ATTN: Document Control Desk
U. S. Nuclear Regulatory Commission
Washington, DC 20555-0001**SUBJECT:**Beaver Valley Power Station, Unit Nos. 1 and 2
BVPS-1 Docket No. 50-334, License No. DPR-66
BVPS-2 Docket No. 50-412, License No. NPF-73
Supplemental Response to Generic Letter 2004-02 (TAC Nos. MC4665 and MC4666)

Supplemental Response to Generic Letter 2004-02
for Beaver Valley Power Station Unit No. 1 and Unit No. 2
Page 1 of 208

Figure 3.o.2.17-1
BVPS-1 Test 6 Differential Pressure and Velocity Versus Time

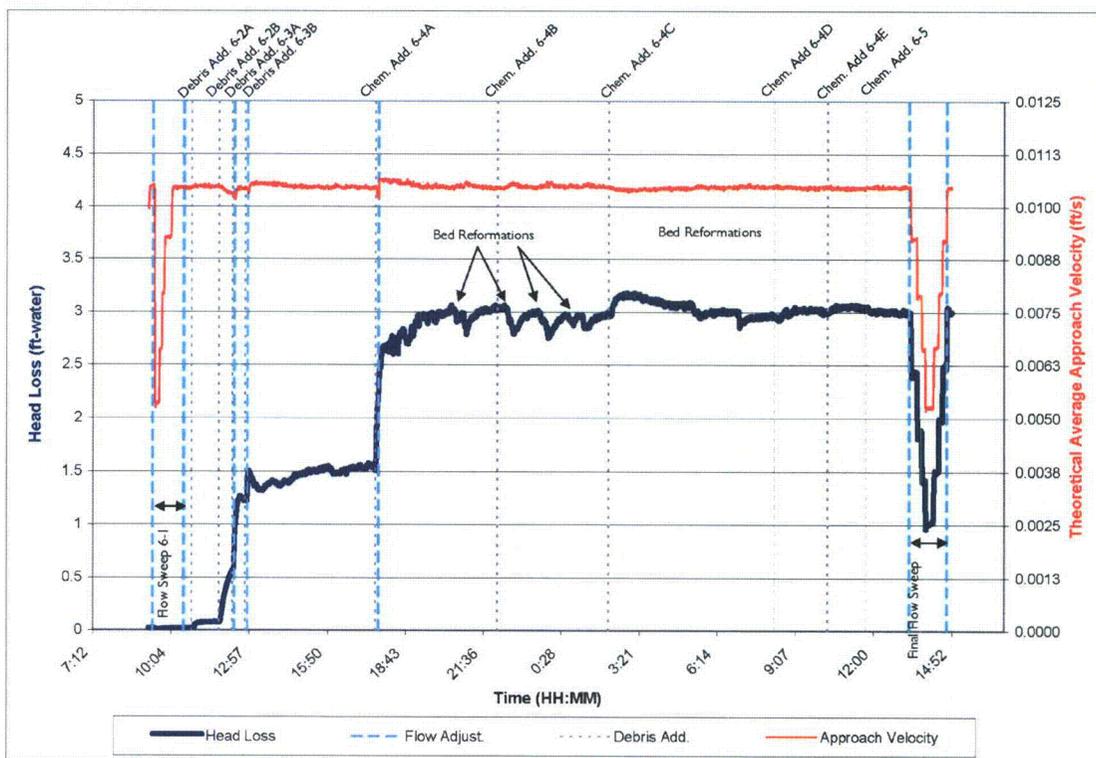
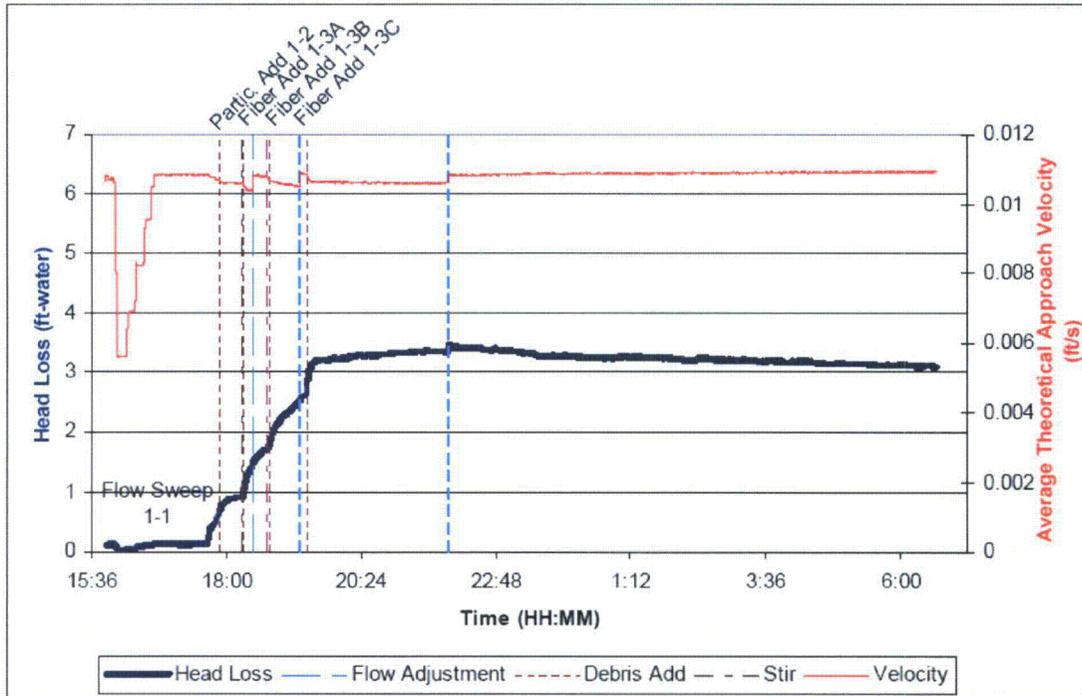
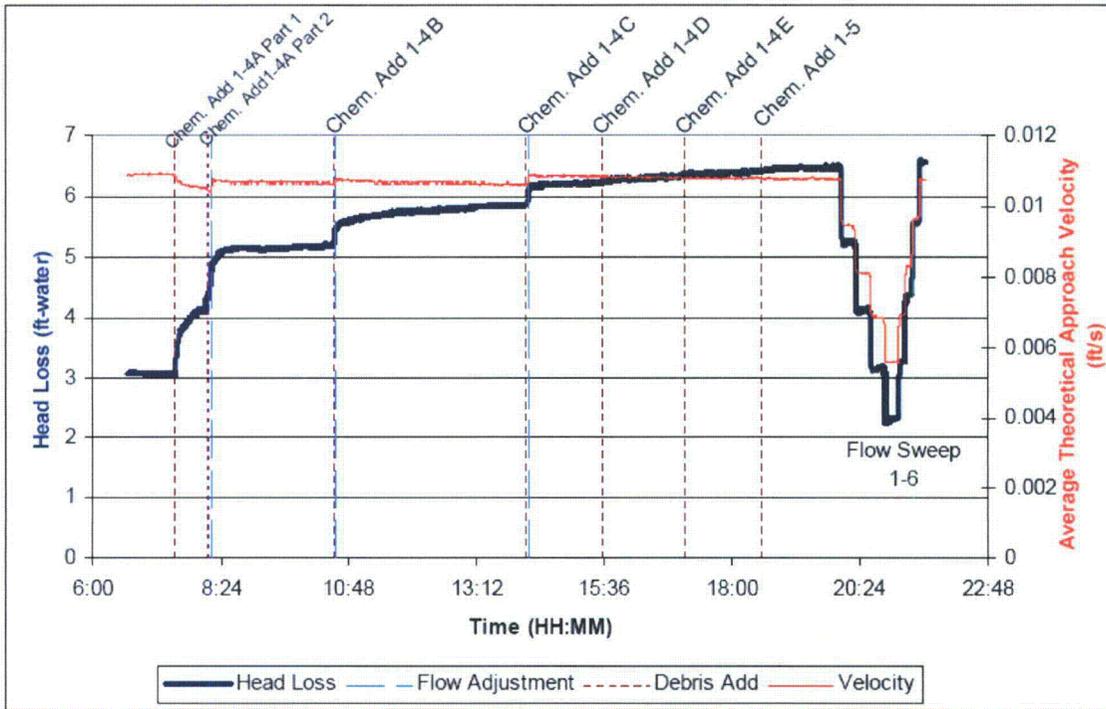
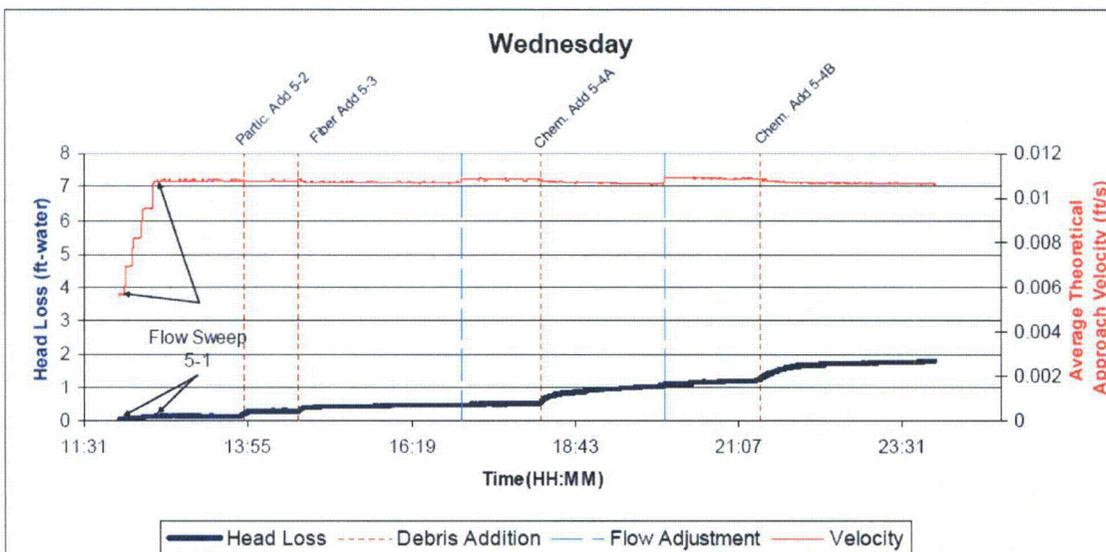
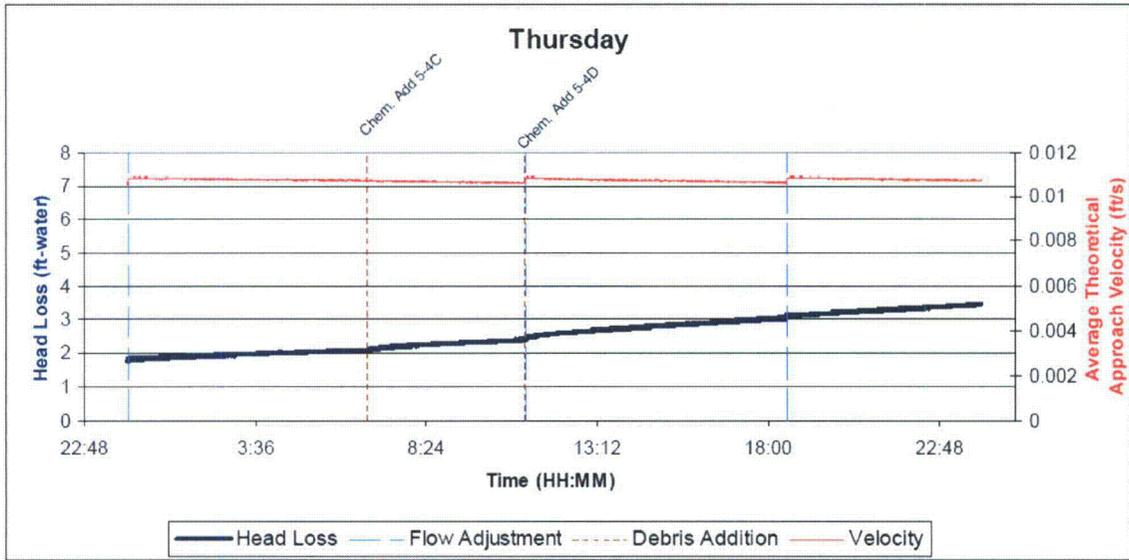
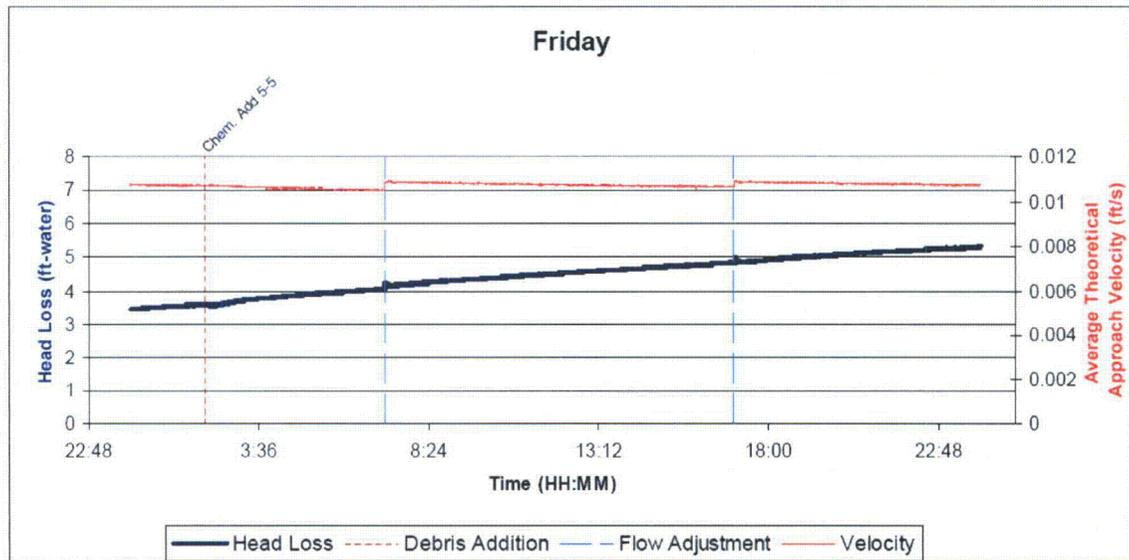
- i. The curves in Figures 3.o.2.17-1 through 3.o.2.17-8 below illustrate the pressure drop as a function of time (uncorrected temperature) for the BVPS-1 and BVPS-2 bounding test configurations.
